NUCLEAR REGULATORY COMMISSION

Title: Advisory Committee on Reactor Safeguards
 Fukushima Subcommittee Open Session

Date: October 19, 2016

Figure 2.1.4-1 Comparison of Current Design Basis Wind Speeds vs Updated Tornado and Hurricane

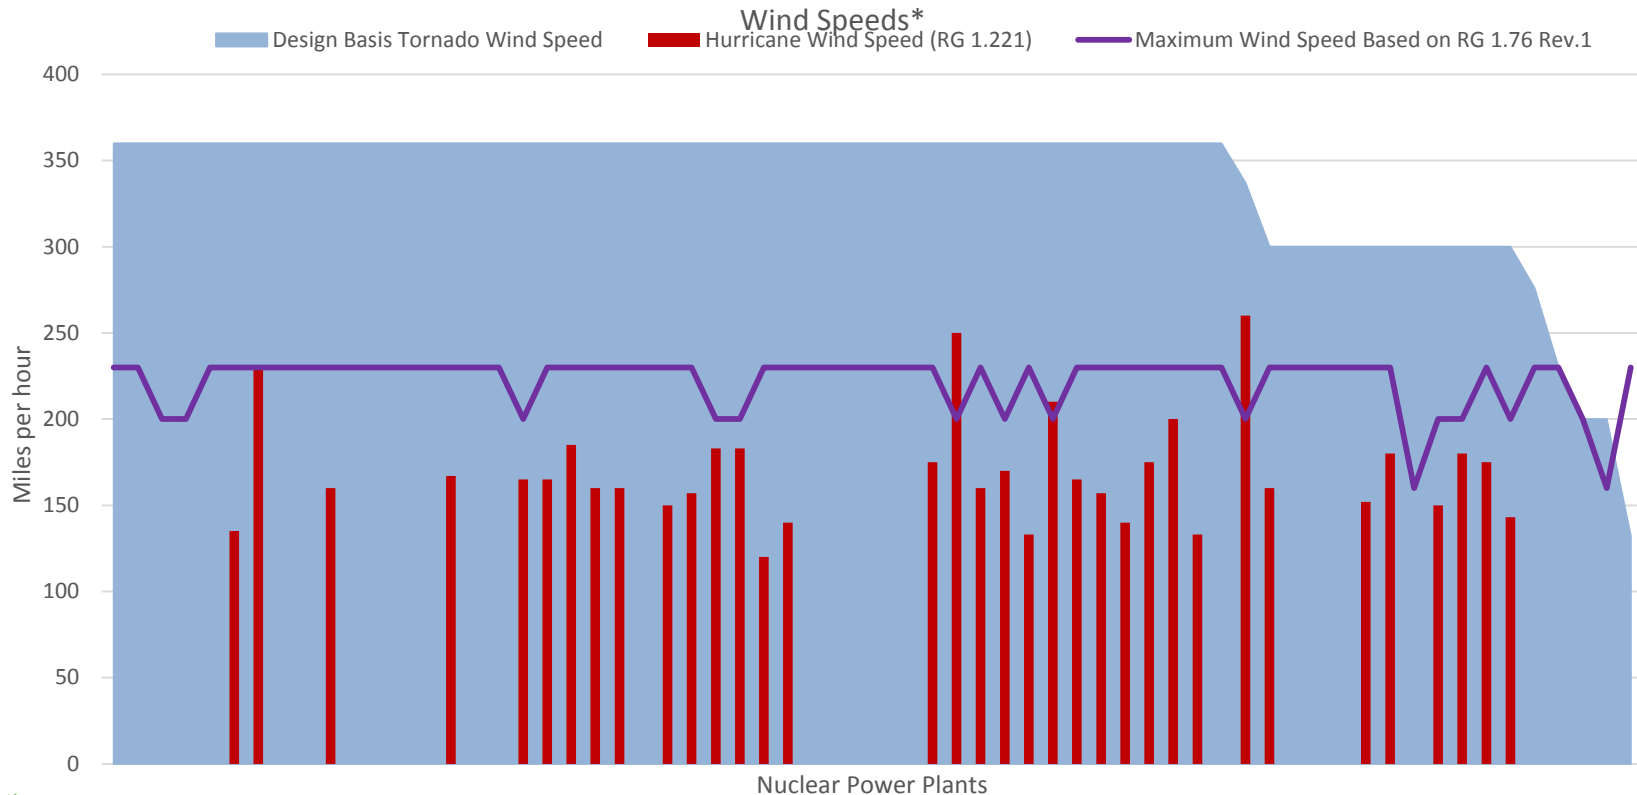
Here you see that this site is not bounded. You have data from a current reg guide for tornadoes that is higher than the design basis. This plant is Ginna.

CHAIRMAN STETKAR: I don't know which of the plants here on this plot is Indian Point and for the moment I don't care.

Now, Ginna. I'm really puzzled about Ginna because Ginna, the argument seems to be that, and this is a quote, "The last site, Ginna did not calculate a core damage frequency, instead noting that as part of the systematic evaluation program review it made several modifications to the plant to increase the protection from high winds."

Maybe I would have concluded it's less than $1\text{E}-30$. What basis for Ginna's risk being that small? Given the fact that its current design basis wind speed is about 135 miles per hour, and the reevaluated wind speed would be whatever that little purple line is there on this drawing.

licensing basis is they are a pre-GDC plant, pre general design criteria.

In the early nineteen eighties there was a review that was done called the Systematic Evaluation Program that took a look at the plants that were licensed prior to the 1975 version of the SRP, including Ginna.

Figure 2.1.4-3 Automobile Missile Speeds

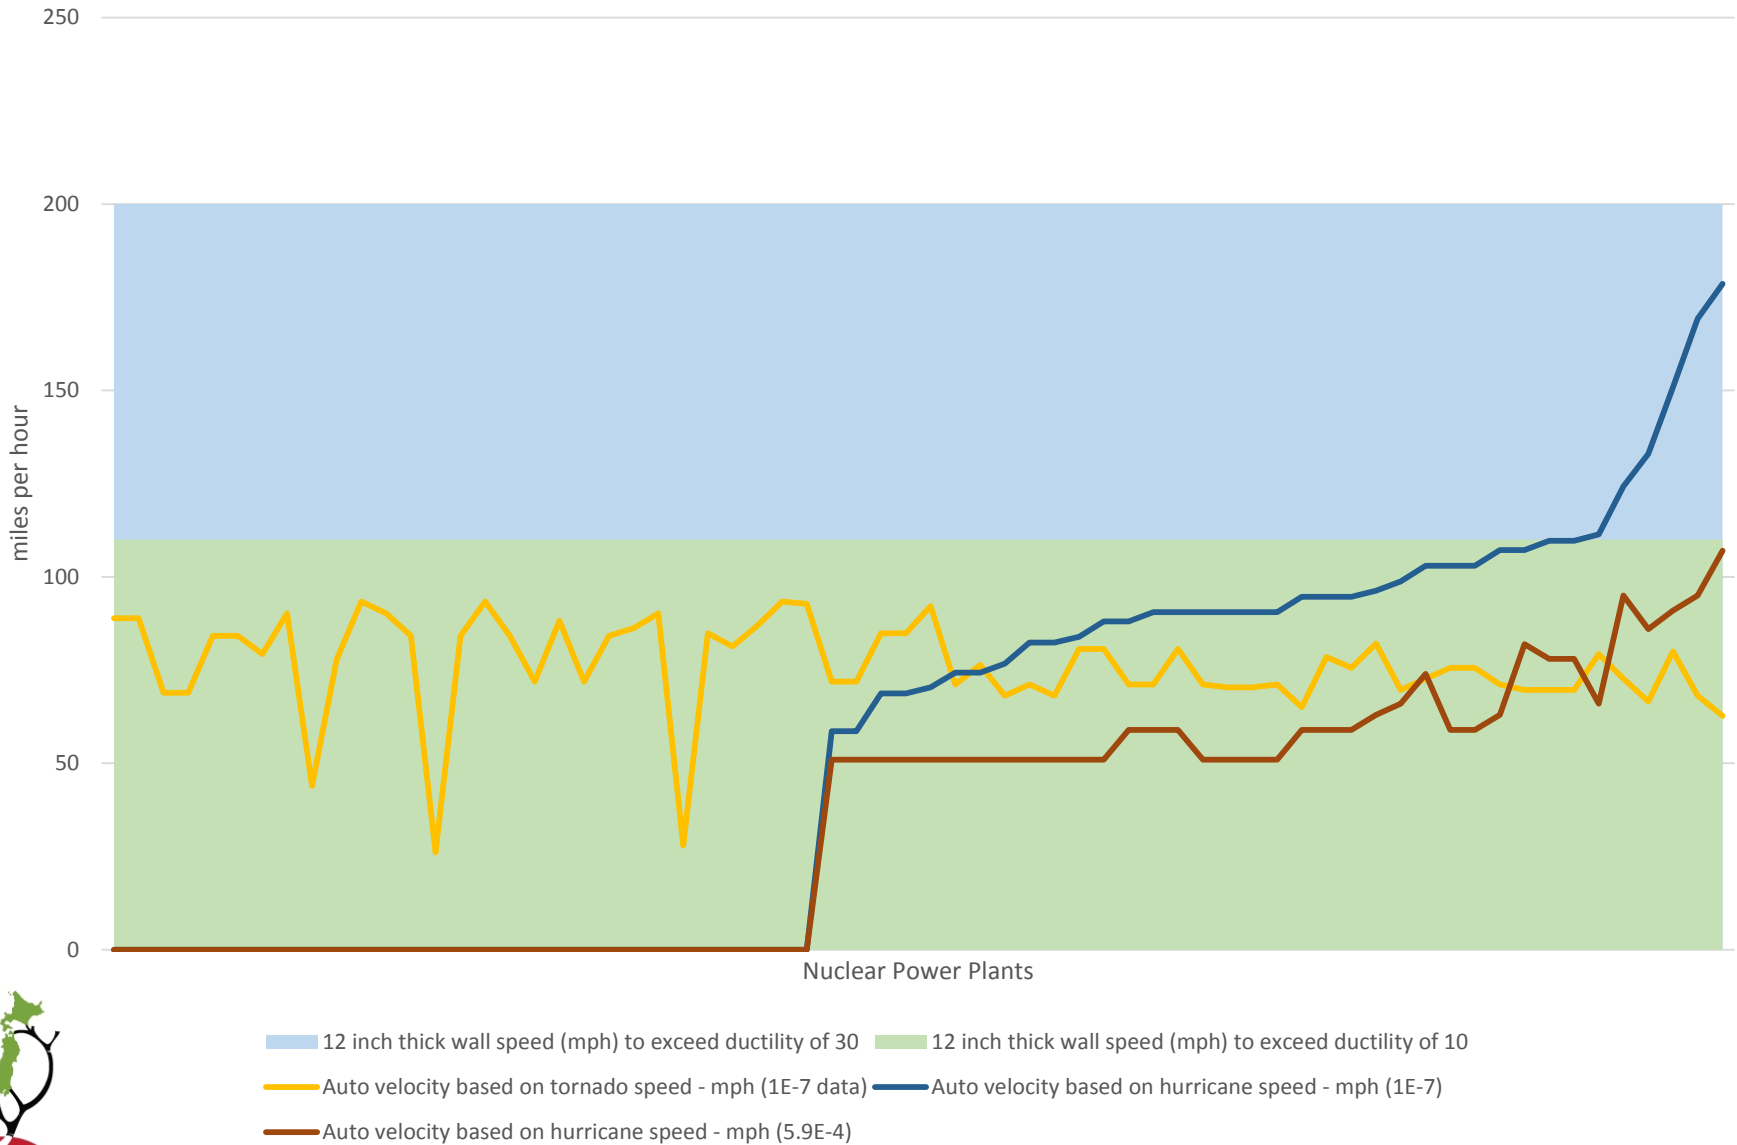
MEMBER SKILLMAN: Joe, let me ask Mo this question. Mo, 12 inches concrete must be supported

CHAIRMAN STETKAR: I did read, and I recollect, I don't have the quote right here though, that the American whatever it is, Society of Concrete people because I don't do this sort of thing design standard says you don't exceed a ductility of 10. Is that correct?

CHAIRMAN STETKAR: Sure, but essentially my question is given normal construction practices would you expect any of the plants in the United States to have that type of ductility, or would they follow normal design and construction standards and have a ductility closer to 10?

Using a ductility factor of 10, 12-inch wall, the automobile would have to be going greater than 110 miles per hour for 18-inch, 180 miles per hour for a 24-inch thick wall. It would have to be going greater than 240 miles per hour. And we'll show this on a plot here in a little bit.

What we say in the paper is, and again, this is just one of the screening tools that was looked at to determine whether or not we had a basis for a regulatory action, that based on this calculation if you had a 12-inch representative wall it can withstand all of the $1E-7$ tornado automobile missile speeds, and all of the $6E-4$ hurricane driven automobile missile speeds. We'll show this graphically in a graph that's coming up.

MR. SHAMS: I would -- knowing the conservatism built in a design and the way we build a nuclear plant I would expect them to have margin that would take them all the way up to 30.
